American Telecommunications Certification Body Inc.
6731 Whittier Ave, McLean, VA 22101

RE: Telematics Wireless, Ltd.

FCC ID: NTAFP200INT

After a review of the submitted information, I have a few comments on the above referenced Application.

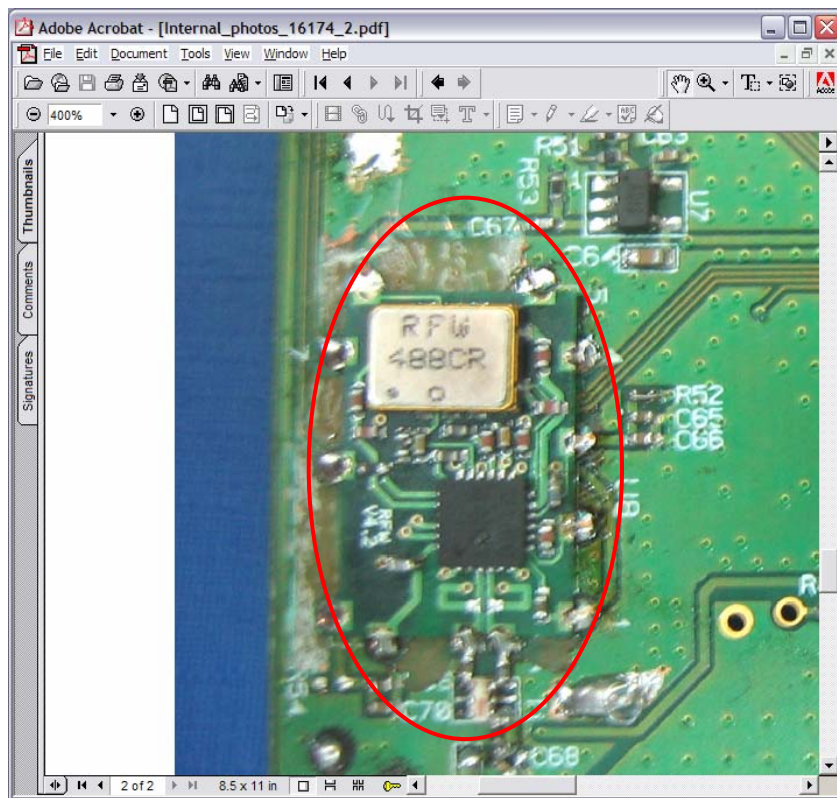
- 1) Please provide bottom views of the RF module/board shown:
